City of Richmond

Report to Committee

RZ 04-272351

APPLICATION BY PARMJIT RANDHAWA FOR REZONING AT

FRONT ELEVATION (WILLIAMS (20AD)

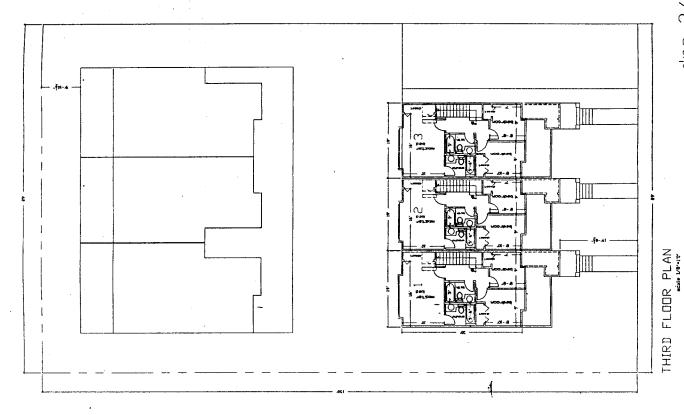
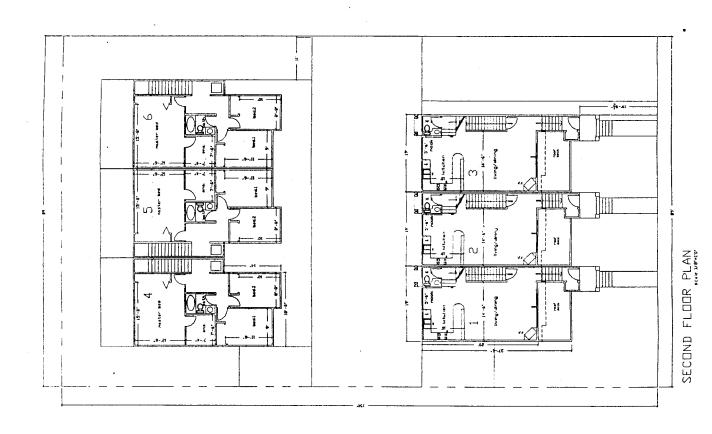
- Revision and articulation of elevations, in particular the street facing elevations, including a review of the quality, type and combination of façade and porch elements and finishing materials;

- O Modification to the roof, including proposed slope, continuous bulk, and review of materials to ensure a high quality finish;
- O Submission and review of a formal landscaping plan prepared by a registered Landscape Architect which provides satisfactory treatment of on-site landscaping including the outdoor amenity areas; and
- O Refinement to the unit layout plans as needed to achieve appropriate improvements to building exterior treatments and design.
- The applicant has been advised of the outstanding design issues, and is in agreement to address these issues through the Development Permit process.
- Review by the Advisory Design Panel will be required as part of the Development Permit process.
